HHH1 HILL HOUSE HAMPSTEAD 87 REDINGTON ROAD NW3

3. COMPARISON BETWEEN EXTANT PERMISSION FOR ANNEXE BUILDING 2014/7140/P
& PROPOSED SCHEME 2020

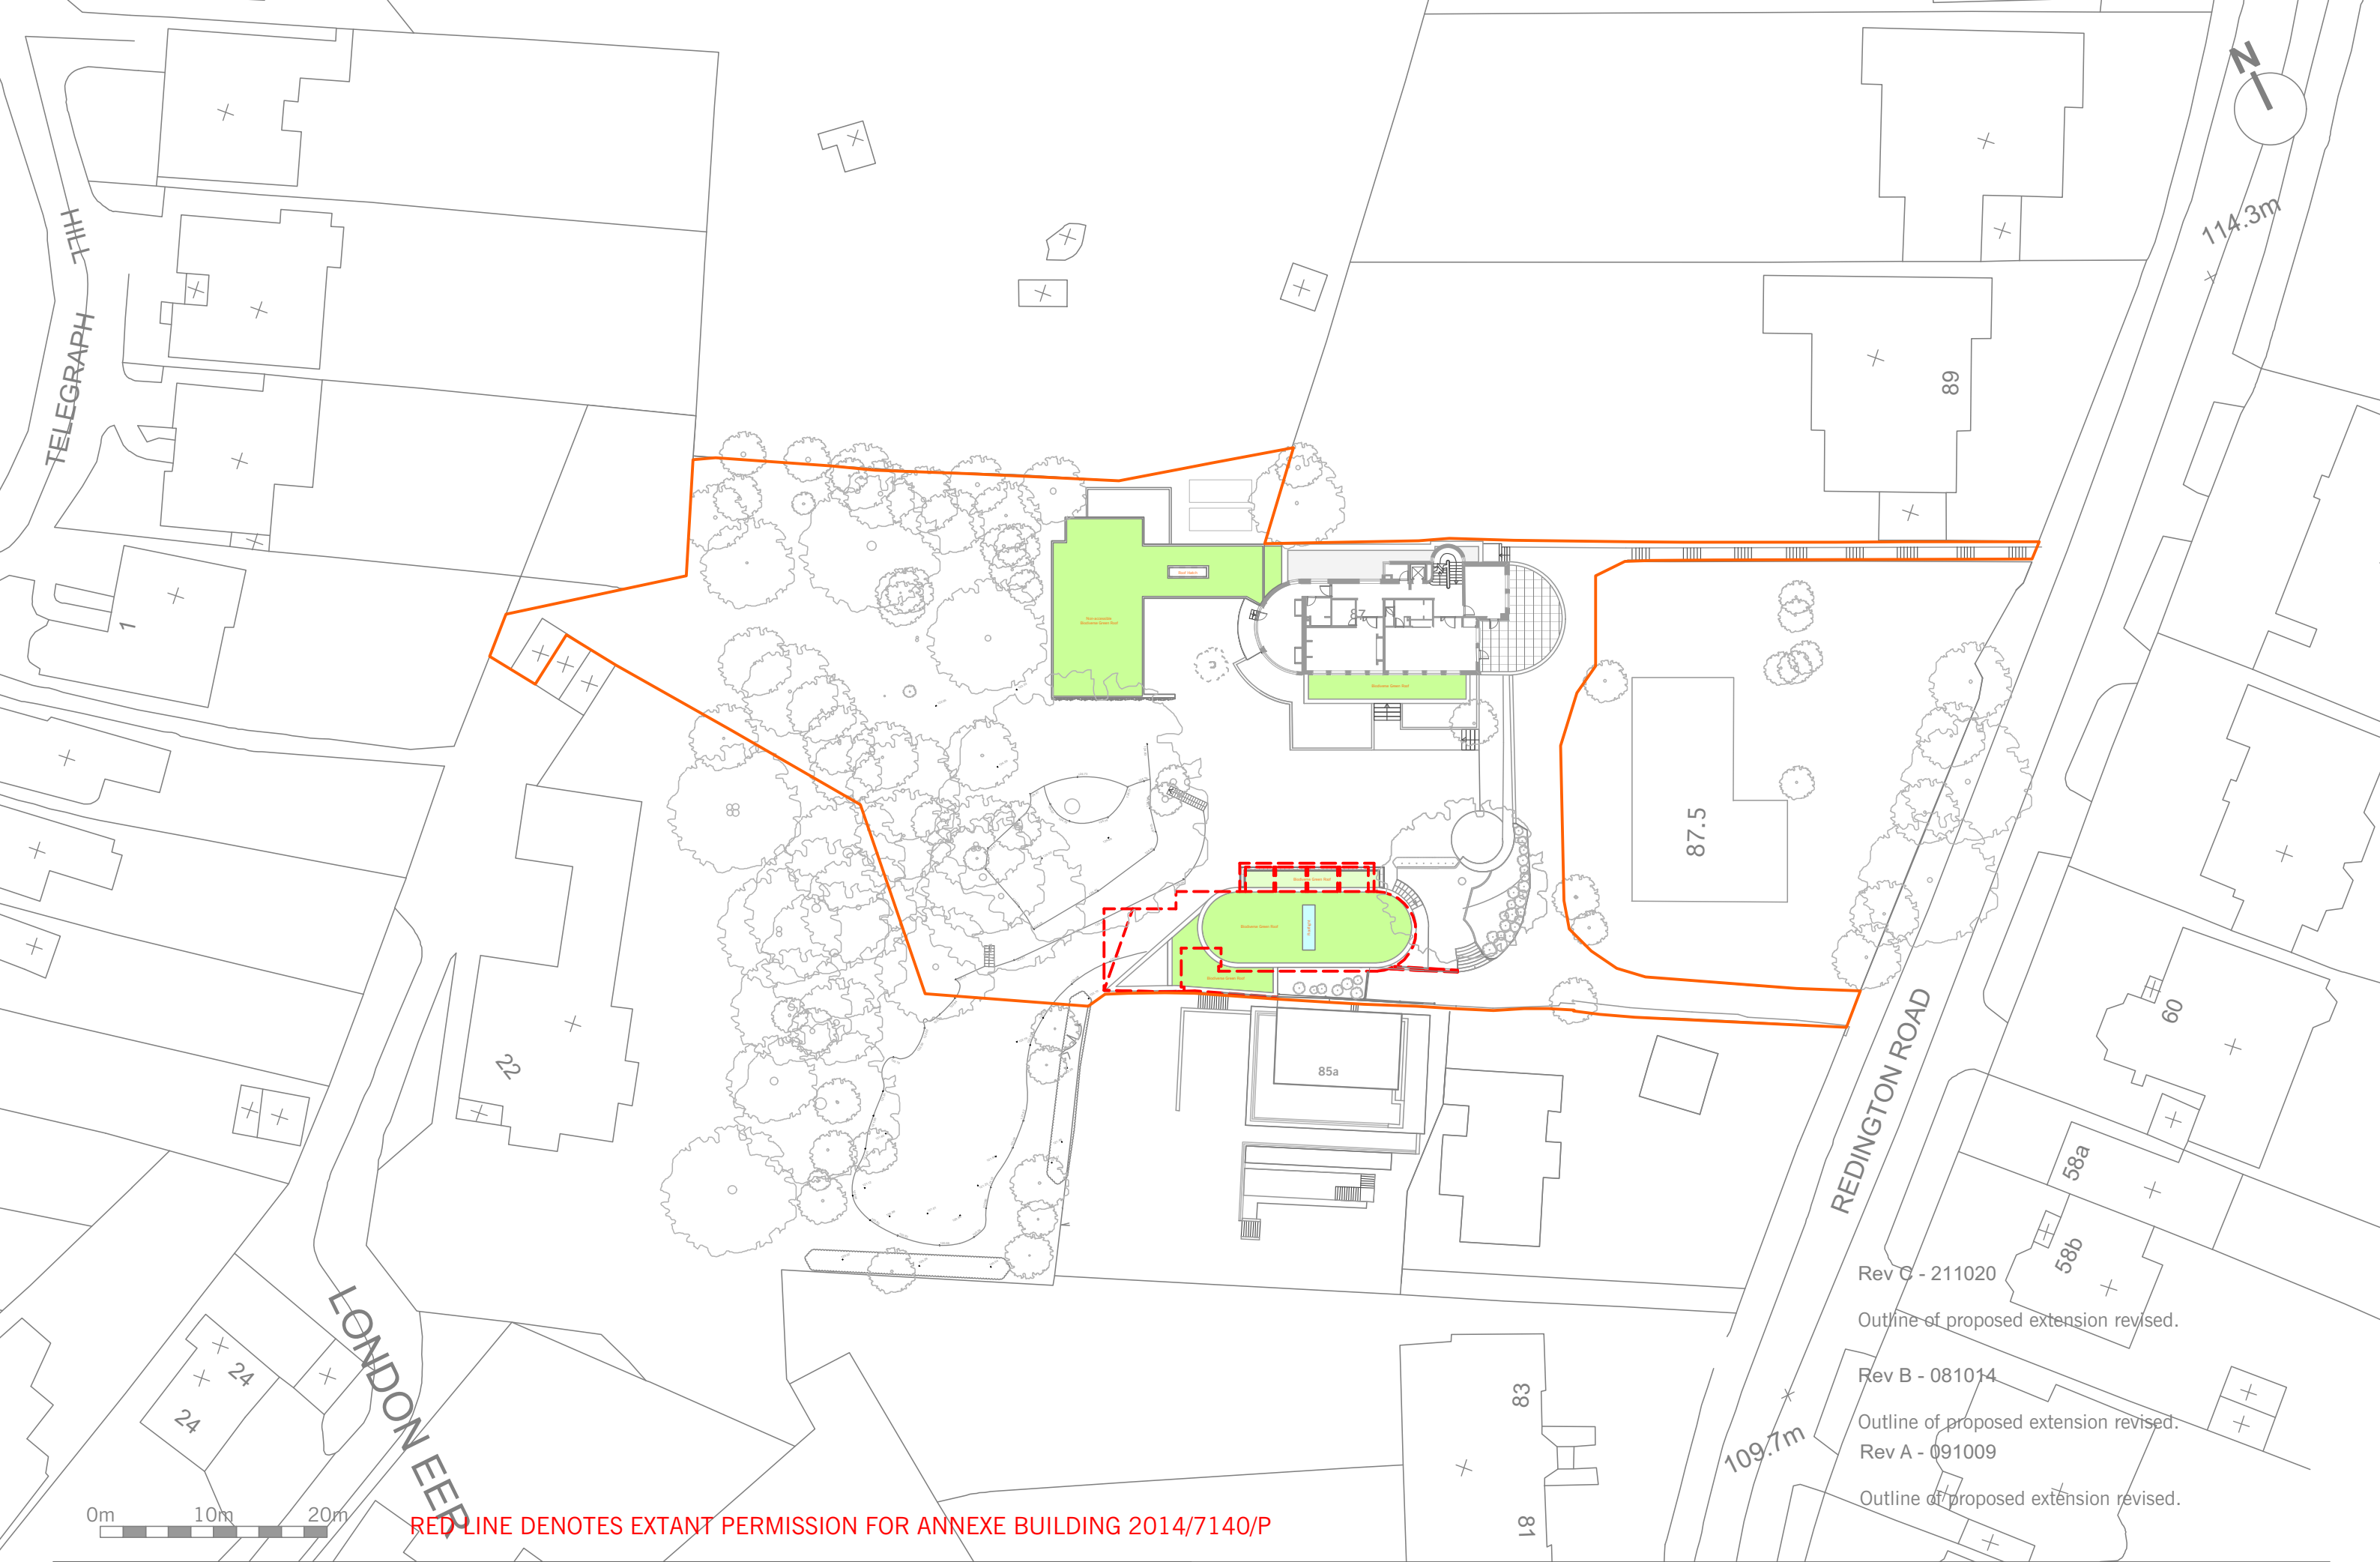
Revised external outline:

- 1] Revised column spacing for arcade
- 2] Reduced footprint of 8M2
- 3] Cut back of north west corner and small increase to the south.
- 4] Removal of courtyard facing onto 85A.
- 5] New roof light over living space
- 6] New obscured glass door for maintenance only to replace obscured glass window to southern boundary.

Revised external outline:

- Arcaded terrace added on the North side
- Building footprint amended as shown

Revised internal layout:

- Reduce of GIA from 169sqm(revB) to 150sqm(rev C)

Dining room and kitchen moved west to protect root ball of poplar T6. Dining room reduced north by 500 mm. Hall widened.

Glass link removed.

South extension cut back to protect root ball of oak T11.

Non-accessible low level planter added to south of annex.

1.2m glazed screens added to prevent access and overlooking to no 85A.

1/3 of library window specified obscured glass and non-openable.

Picture window added to west elevation of rear extension.

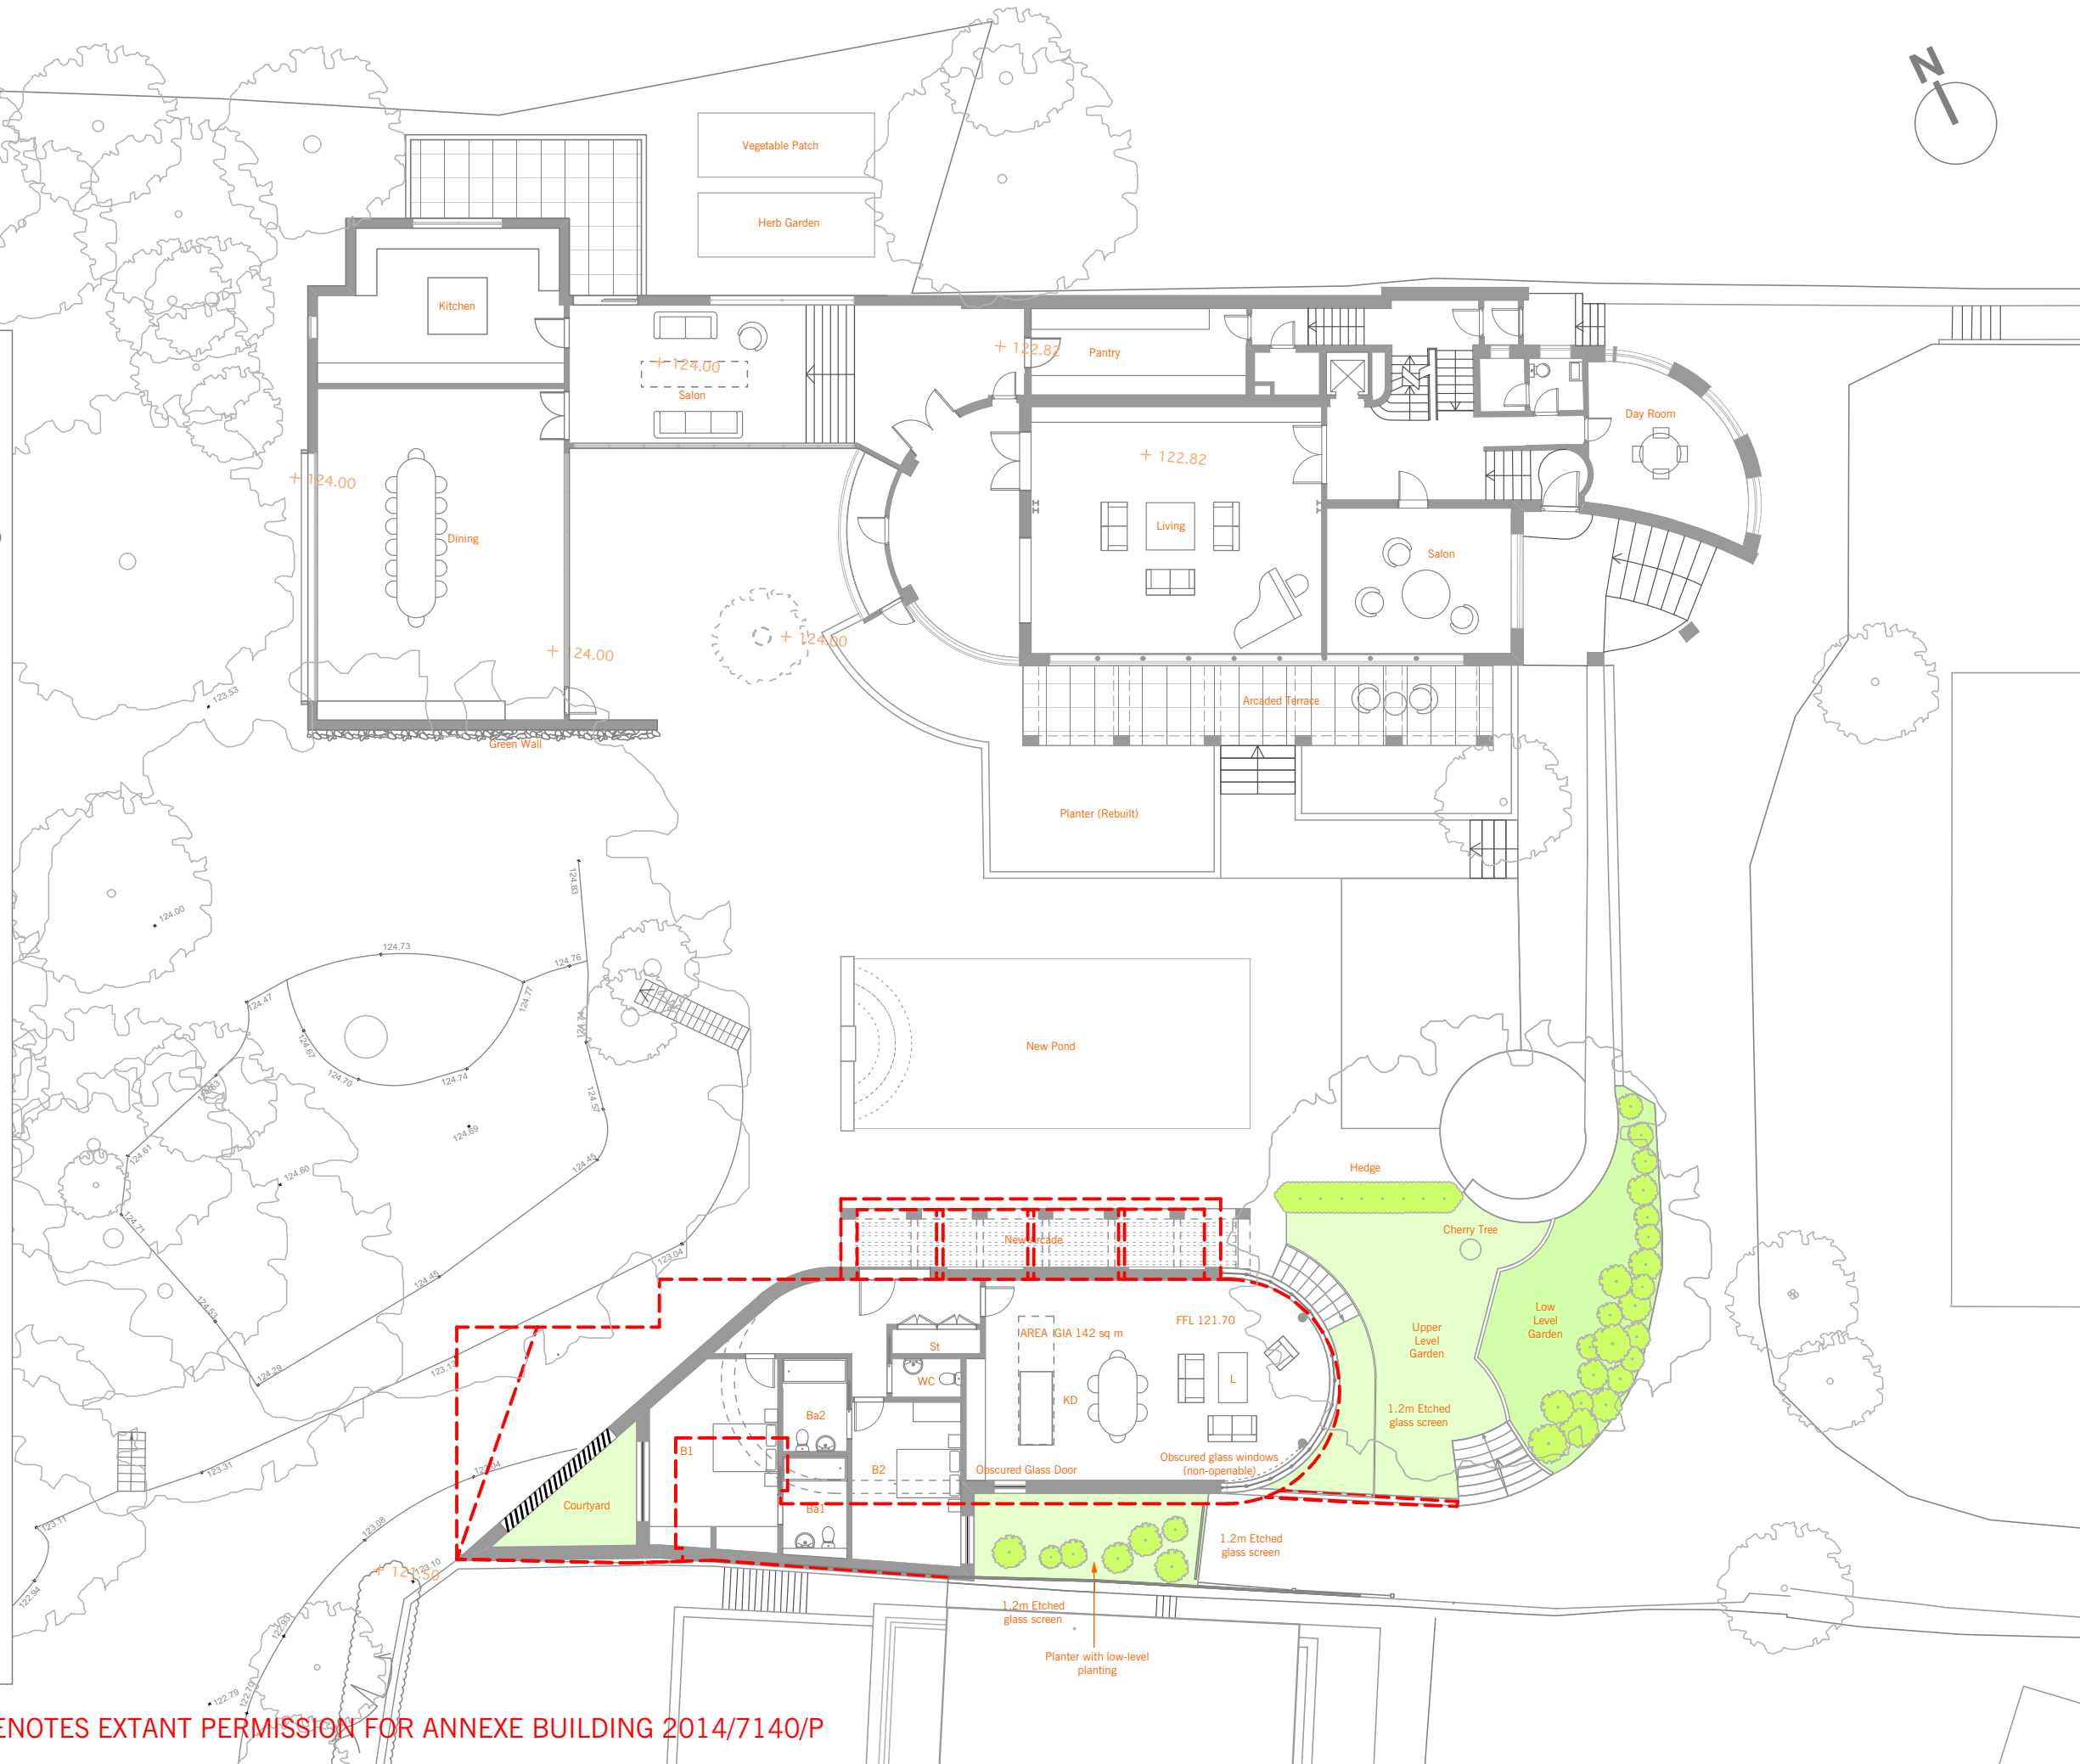
Revised external outline:

- 1] Revised column spacing for arcade
- 2] Reduced footprint of 8M2
- 3] Cut back of north west corner and small increase to the south.
- 4] Removal of courtyard facing onto 85A.
- 5] New roof light over living space
- 6] New obscured glass door for maintenance only to replace obscured glass window to southern boundary.

Outline of proposed extension revised.

Glass link removed.

Roof of proposed extension revised.

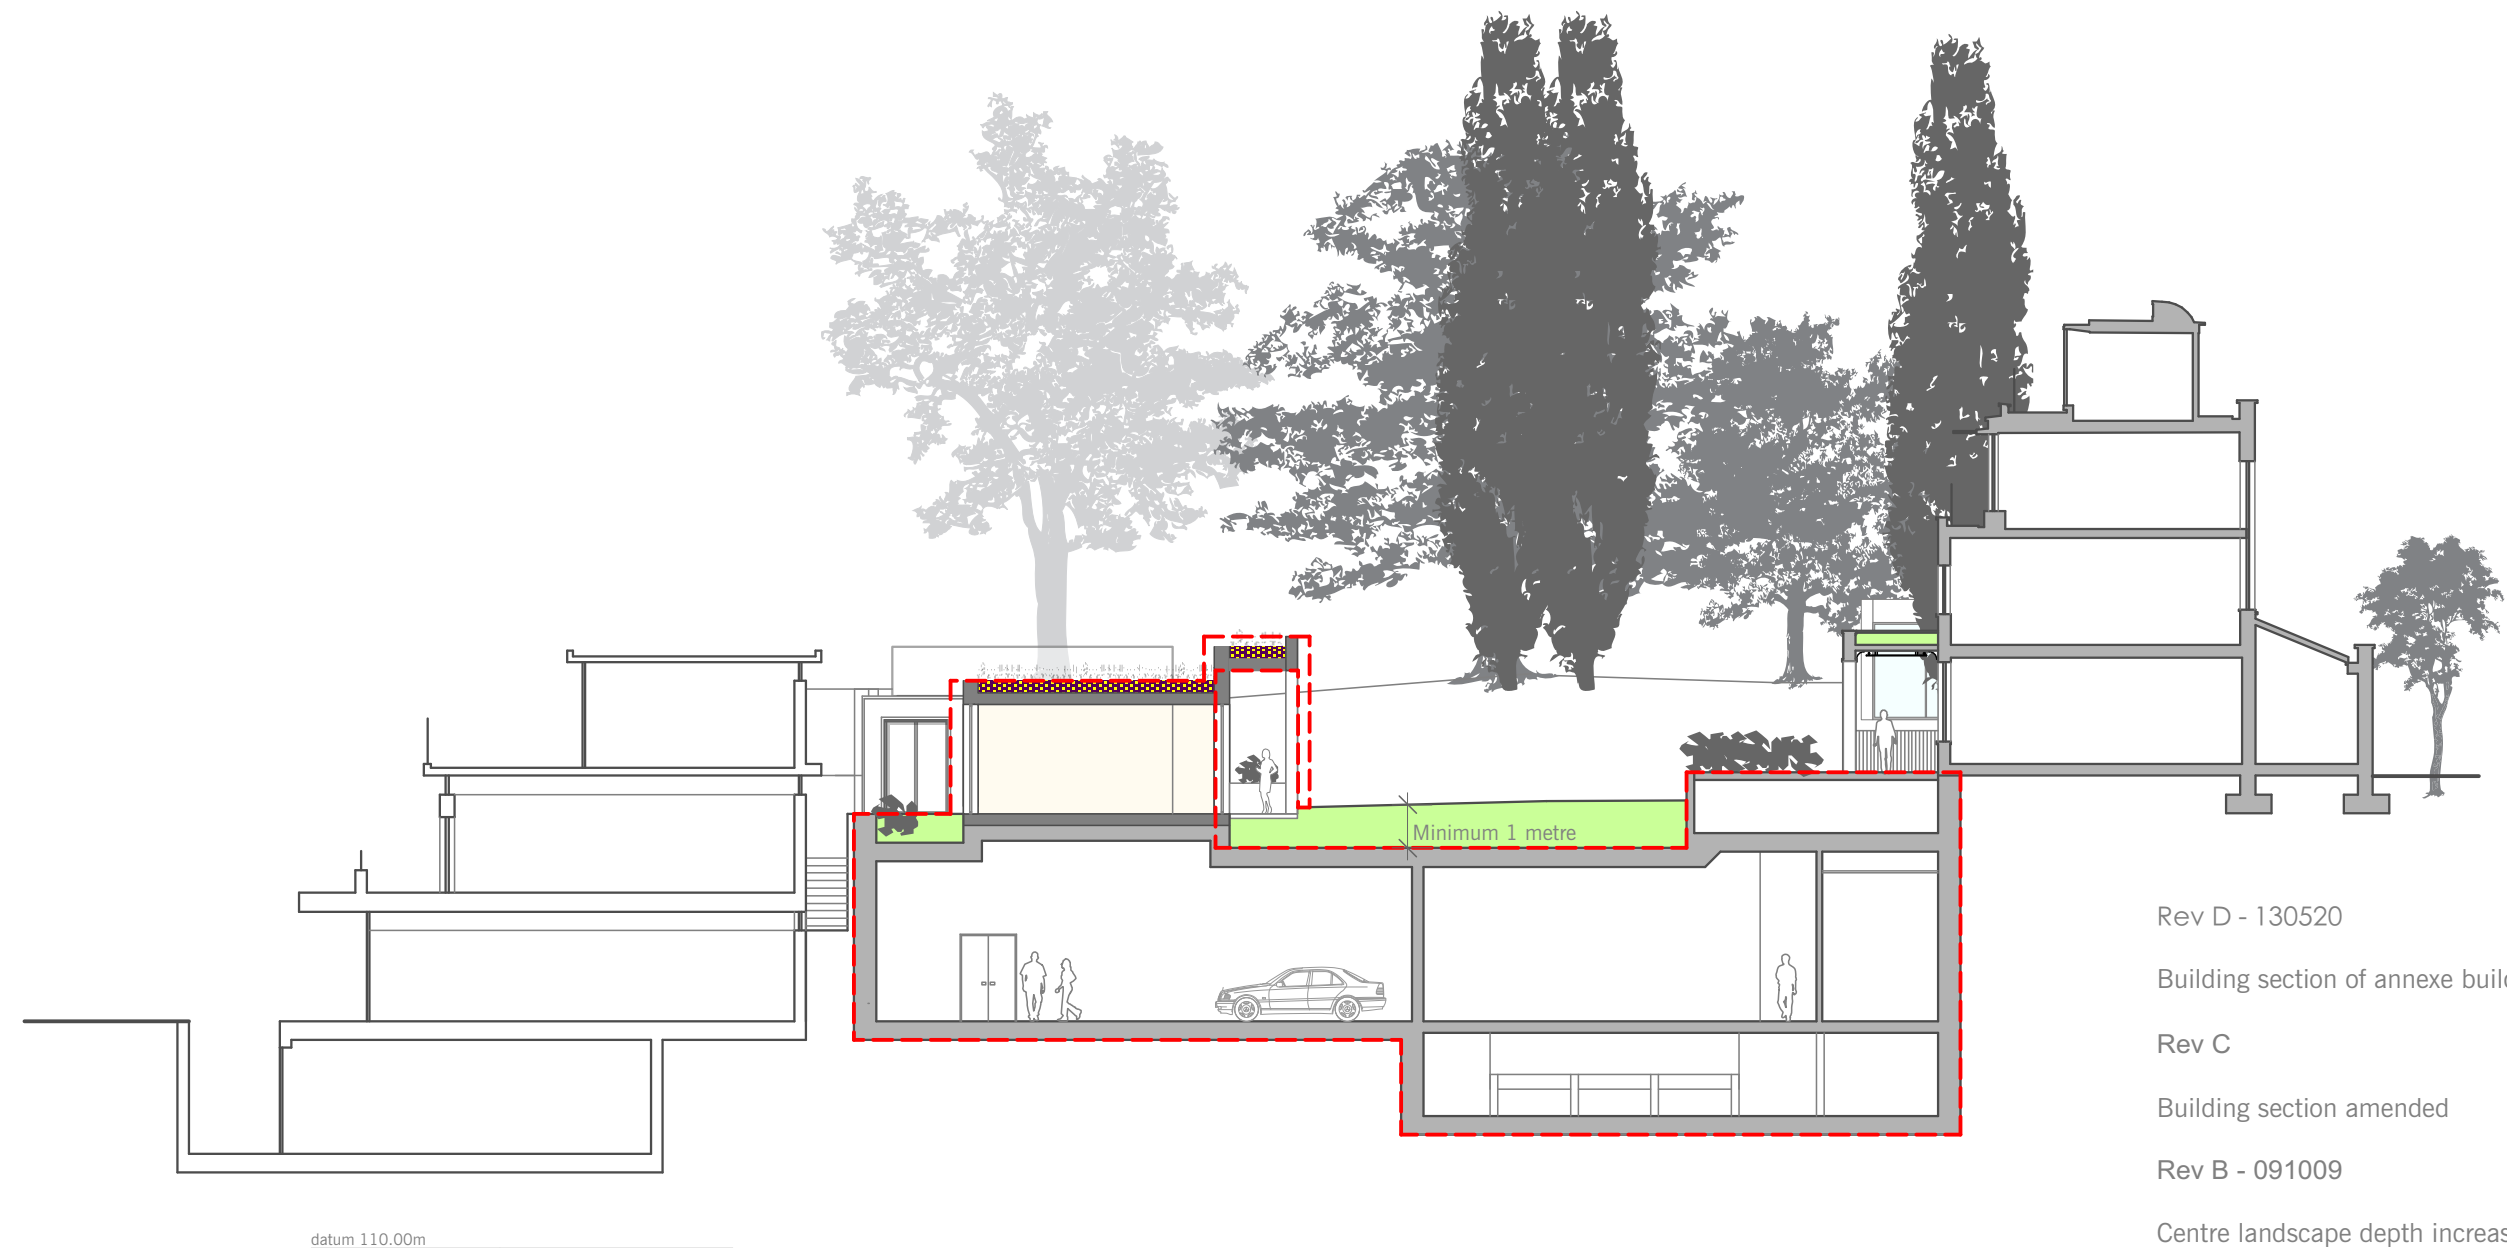
Planters added to annex roof.

Glazed screen added to annex roof to prevent access.

Building section of annexe building amended

Building section amended

Centre landscape depth increased.

Non-accessible low level planter added to south of annex.

1.2m glazed screens added to prevent access and overlooking to no 85A.

1/3 of library window specified obscured glass and non-openable.

Planters and guarding added to roof of annex at rear.
